AERONAUTICAL CHARTING FORUM
Instrument Procedures Group
October 29, 2013

FAA Control # 13-02-313

Subject: Chart Notes for Simultaneous Approaches.

ILS or LOC RWY 26R

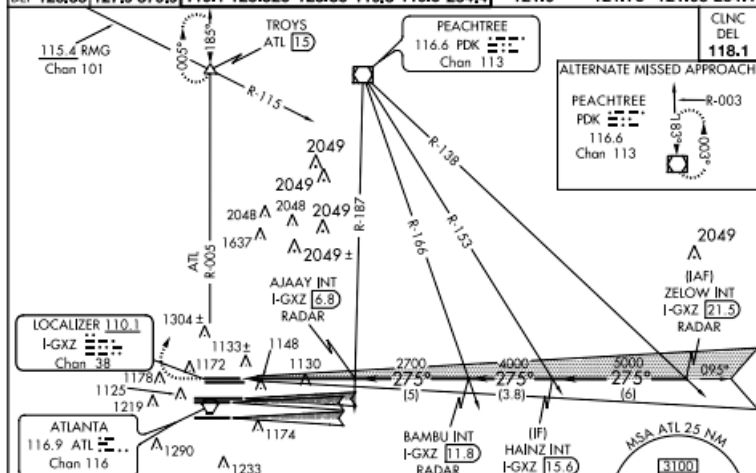
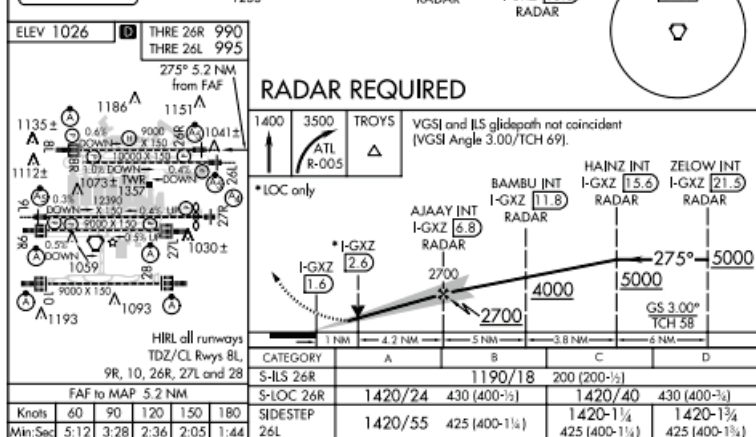
As a result, the briefing strip may be cluttered with a sizable list of approaches which occupy space that could be reduced in size, thus emphasizing the more critical notes depicted in the briefing strip. The following example of the Atlanta (ATL) ILS or LOC RWY 26R briefing strip serves to illustrate this point. First, the notes in the briefing strip do not presently comply with the 8260.19E, paragraph 8-54m(7)(b), guidance because the approach is not authorized to be conducted with the ILS PRM 27R, ILS PRM 27L, or ILS PRM 28 approaches and hence all approaches authorized for simultaneous operations must be listed. That being the case, the chart note should read, “Simultaneous approach authorized with ILS or LOC RWY 27R, ILS or LOC RWY 27L, ILS or LOC RWY 28, ILS (SA CAT I) RWY 28, ILS (CAT II) RWY 28, ILS or LOC RWY 27R, ILS or LOC RWY 28, ILS (SA CAT I) RWY 28, ILS (SA CAT II), RNAV (GPS) RWY 27R, RNAV (GPS) RWY 27L, RNAV (GPS) RWY 28, RNAV (GPS) RWY 27R, RNAV (GPS) RWY 28, RNAV (RNP) RWY 27R, RNAV (RNP) RWY 27L, RNAV (RNP) RWY 28, RNAV (RNP) RWY 27R, RNAV (RNP) RWY 28.”

For inop MALSR, increase Sidestep Rwy 26L Cats A and B visibility to RVR 6000. Simultaneous approach authorized with Rwy 27L or 27R or 28, or Rwy 27R and 28.

If this process were used for RWY 26R at ATL, the briefing strip would be as follows:
“Simultaneous approach authorized with RWY 27R and RWY 28 except ILS PRM 27R, ILS PRM 28, ILS PRM (SA CAT I) RWY 28, ILS PRM (CAT II) RWY 28.”
